# **Consistency Assessment Approval Form**

Existing Approved Project	
Planning approval reference details (Application/Document No. (including modifications)):	
SSI_7400 Sydney Metro Chatswood to Sydenham	
Date of determination:	
9 <sup>th</sup> April 2017	
Type of planning approval:	
Critical State Significant Infrastructure

The haulage routes as amended by this document apply to Demolition stage only.

Figure 1 Haul roads as shown in the EIS for Pitt St site.

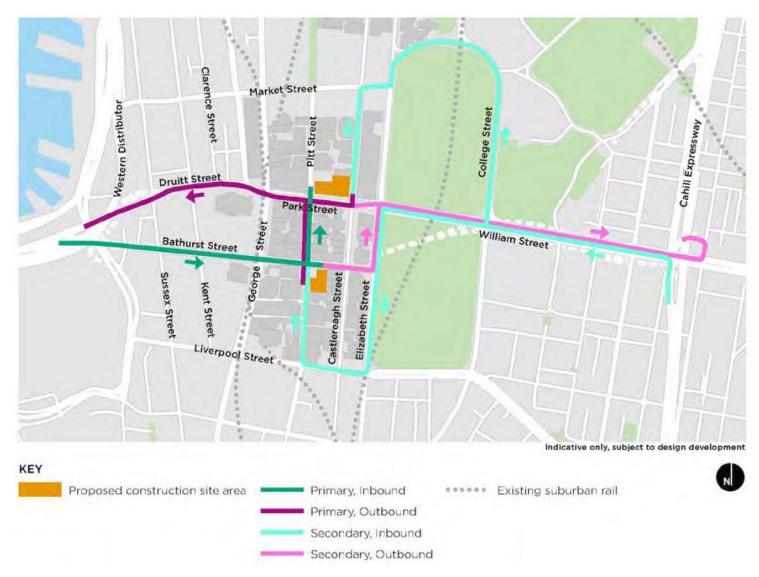
During detailed design it was identified that the right hand turn shown in the EIS haul route from Pitt St south site, Castlereagh Street onto Park Street would result in the trucks coming too close to the kerb/footpath.. Hence a new route is proposed which is the subject of this assessment. The new route would continue on Castlereagh Street until Goulburn St, where the trucks would then turn right and continue onto Harbour St and then onto the Western Distributor.

Generally the haulage of demolition from this site and access to this site will be in alignment with the EIS routes, with the exception of the extension of Castlereagh St southbound to a right hand turn into Liverpool Street, and then along Liverpool, with a right hand turn onto the Western Distributor.

Pitt Street (175 Castlereagh Street) site - it is impossible to get into the kerb side lane to complete the right turn into Park Street - hence why the use of Castlereagh Street and Goulburn Street. the use of Pitt Street as noted in the EIS cannot occur for this stage of demolition as the sites are not vacant. The route is the most direct route available onto the Western Distributor

## Figure 3.5 : Chatswood dive site haulage routes Figure 2 Haul roads as shown in the EIS for Chatswood Dive site.

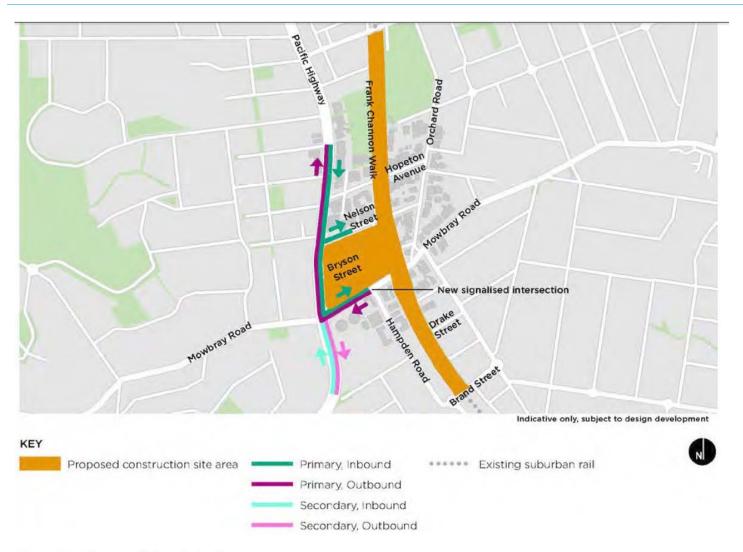
The haul route indicated in the EIS had assumed the new signalised intersection of Mowbray Road and Hampden Road had been constructed. However it has not, and is not likely to within the timeframe of demolition works occurring at this site.

Instead the haul road would be left out of the Chatswood site, onto Mowbray Road and continue along Mowbray heading east.

Generally the haulage of demolition from this site and access to this site will be in alignment with the EIS routes, with the exception of the extension of a right hand turn onto Mowbray Road from the site and headed along Mowbray Road eastbound.

Chatswood - the EIS currently has no haul traffic to the east of the site - however, this is due to the signals that will be installed for the TSE contractor's operation.

Figure 3.13: Crows Nest haulage Routes Figure 3 Haul roads as shown in the EIS for Crows Nest site.

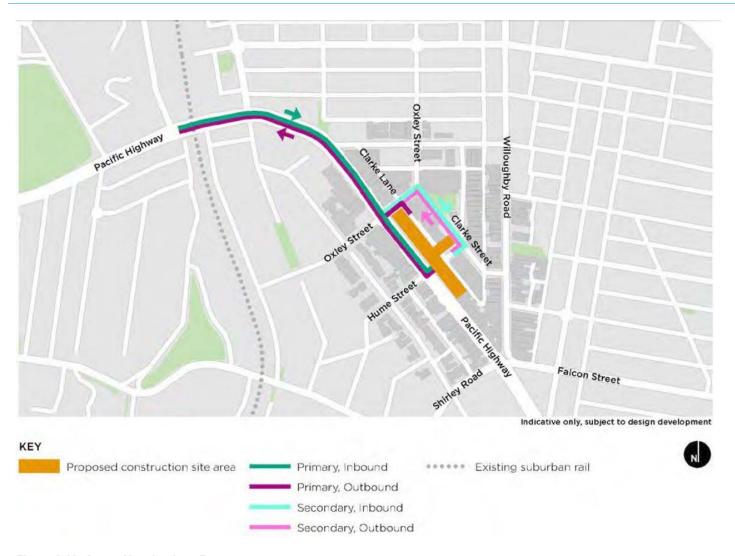
The EIS indicative drawing had not shown a small blank section of Hume Street where it joins to the buildings to be demolished. This section should have been coloured to indicate this is also part of the haul route.

Additionally it was not indicated in the EIS that the entire length of Clarke Lane Crows Nest would be utilised for Demolition Haulage, however that would now occur – this route would replace vehicle haulage on Clarke Street which was shown in the EIS.

Generally the haulage of demolition from this site and access to this site will be in alignment with the EIS routes, with the exception of the extension of an additional 30m of Hume St utilised to access the construction site.

The entire length of Clarke Lane would be used for Haulage – not just part of it as was indicated in the EIS. This access will replace the use of Clarke Street. Clarke Lane is adjacent to the construction site.

Demolition construction traffic will be directed off Clarke St and contained within Clarke Lane adjacent to the construction site. There is direct access off Clarke Lane into the demolition site. This change is as a result of consultation with the Traffic Transport Liaison Group.
